AGENDA
PLANNING AND ZONING COMMISSION MEETING
CITY OF CREVE COEUR, MISSOURI
MONDAY, OCTOBER 19, 2015
7:00 PM

NEW BUSINESS**1. Application #14-022: Revised Site Development Plan Approval at the Shoppes at Westgate**

**APPLICATION TO PLANNING AND ZONING COMMISSION
#14-022 FOR REVISED SITE DEVELOPMENT PLAN APPROVAL
AT THE SHOPPES AT WESTGATE**

Figure 6: Close-up of northeast corner area of the existing fountain, proposed bench and flagpoles.

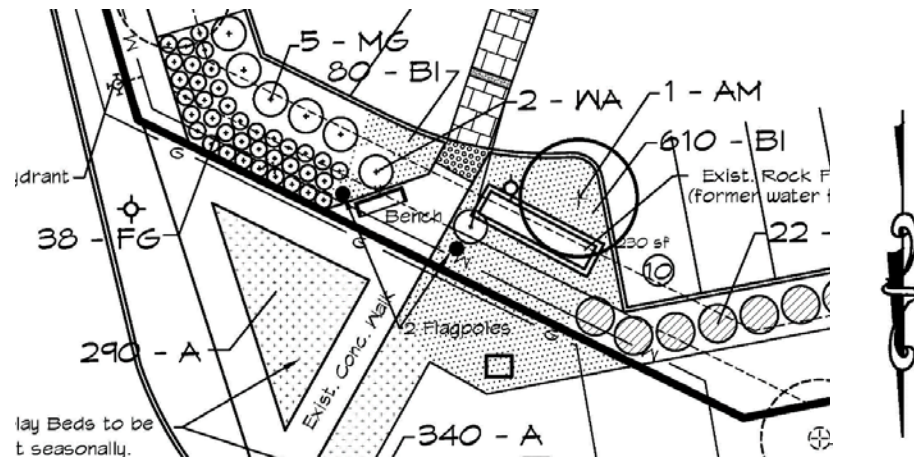
The current proposal includes replacing with new landscaping (some of which is within MODOT right-of-way), adding the bench seating and two flag poles at the northeast corner per the drawing below:

3. The landscape plan shall be revised to include the same number of plantings throughout the site to be consistent with the prior approved plan for the Zoning Administrator's approval.

Figure 7: Close up of the proposed changes to the plaza area at the front/entrance of the building.

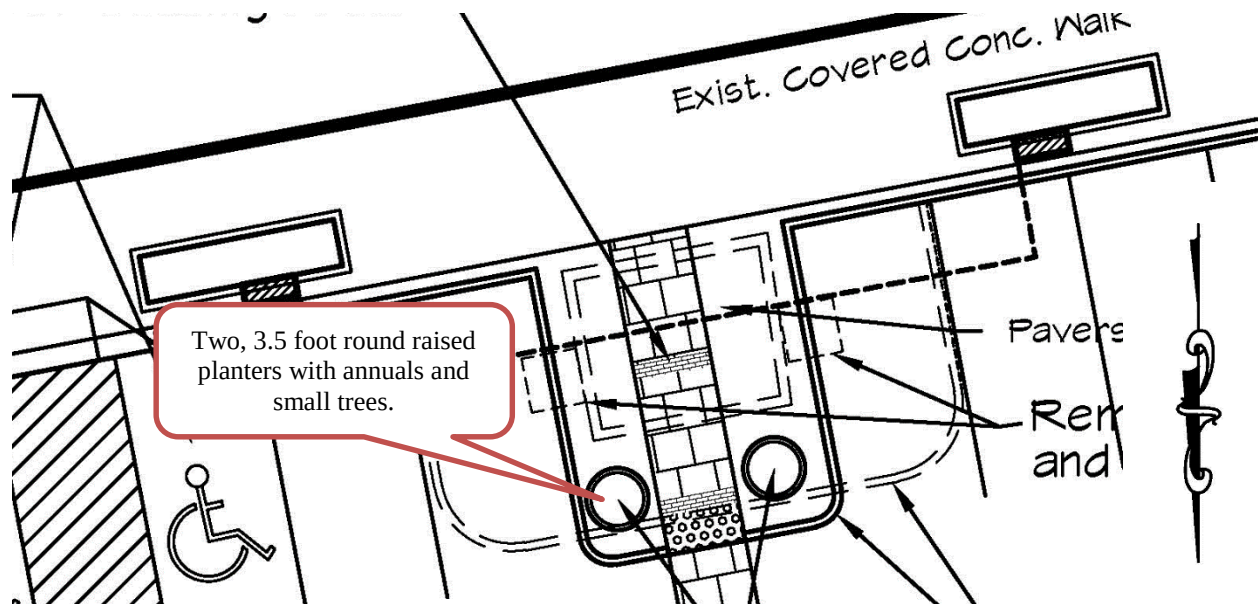
The plaza/dining area proposal include removing the existing planters, narrowing the overall space and adding two round raised planter with annuals and small ornamental trees:

2. Pedestrian open spaces, such as covered walkways, courtyards, and plazas, are encouraged. While the planter in the middle of the existing plaza limits the outdoor dining area, the narrowing of the plaza area for more parking is counter to the Design Guidelines. The remaining plaza area appears under-scaled with the site and limits the purposes even further than the current design. Simply maintaining the existing width of the plaza area and removing the planter to allow for more seating would greatly enhance the proposed plaza area.

4. The plaza/outdoor seating adjacent to the building shall be maintained. The landscaped planter may be removed to allow for greater pedestrian flow and more outdoor seating, in furtherance of the Design Guidelines.

Figure 8: Close-up of the Site Plan of the middle sidewalk from Olive to the building entrance.

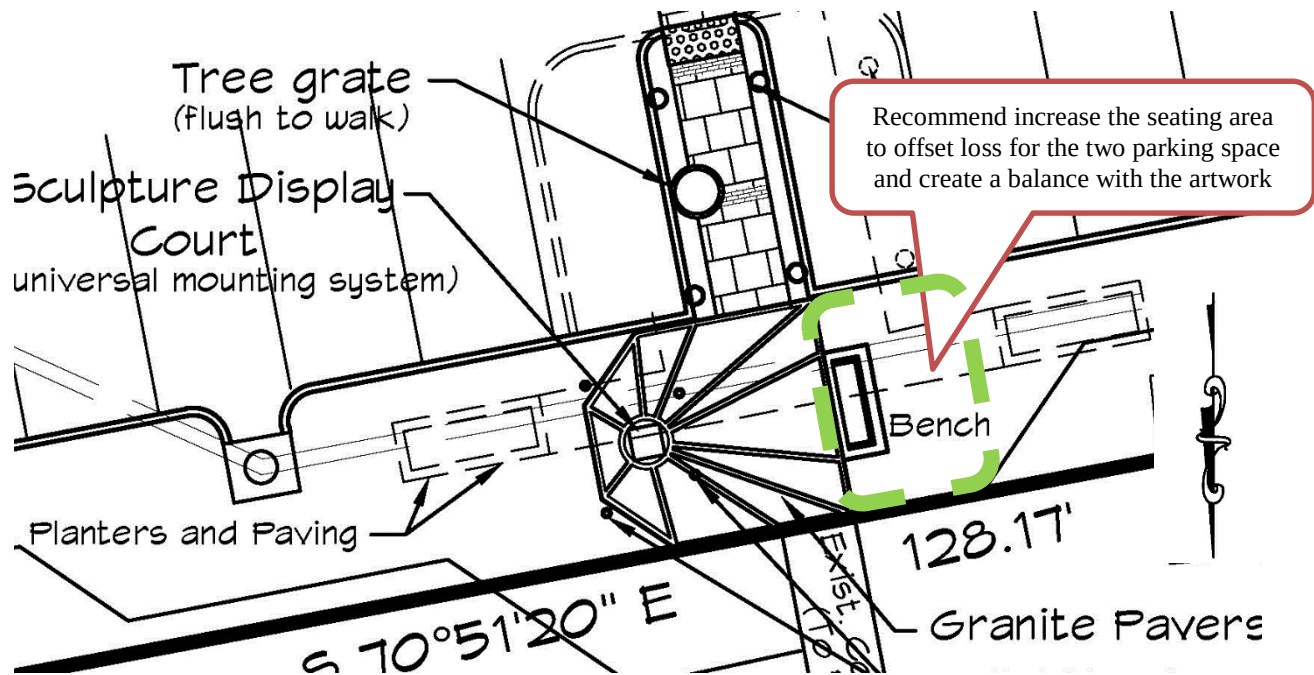
Section 405.730(A)(2) of the Zoning Ordinance states that the minimum width of internal sidewalks in non-residential developments shall be at least six feet or eight feet if used as a curb stop. The site plan indicates that the sidewalks are five feet in width. However, they are not adjusting most of the sidewalks already on site. However the pedestrian connection within the newly created plaza seating is maintaining a five foot path, and across the drive aisle along Olive, and the tree grate narrows it further to three feet, per the image below:

Staff recommends that any new sidewalk area shall have a minimum of six feet in width to meet with the minimum standards of the Code. As mentioned above the location of two tree may be moved to in front of the stall and low landscaping provided on either side of the walkway. The loss of plaza seating at this location should be shifted to sculpture display area, by increasing the seating area and create balance.

NORTH ELEVATION - PROPOSED

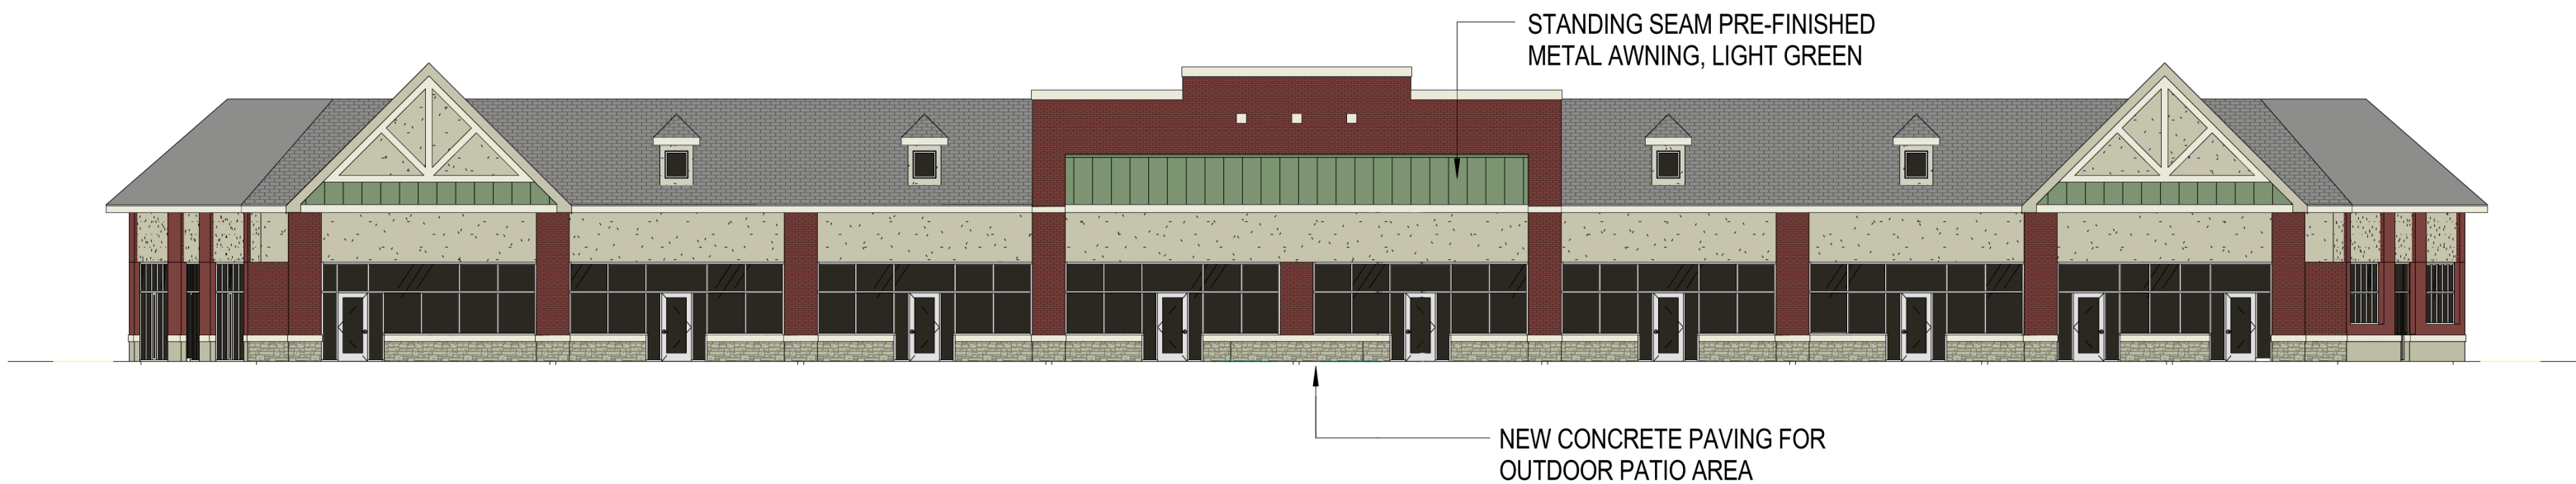
The Applicant is seeking to remove the canopy element on the front of the building and replace it with a standing seam pre-finished metal awning and further to narrow the plaza area adjacent to the building and across the drive aisle to create four additional parking spaces, per the drawings below:

elements, and only minimally meets with the Design Guidelines and Comprehensive Plan. While Staff is generally okay with the addition of the two parking spaces at the northeast corner, our primary concern is with the changes to the elevation of the building, the narrowing of the entry plaza/seating, and the walkway from it to Olive Boulevard. Based on the discussion above, the following items still represent specific decision points for the Planning Commission to discuss with the Applicant:
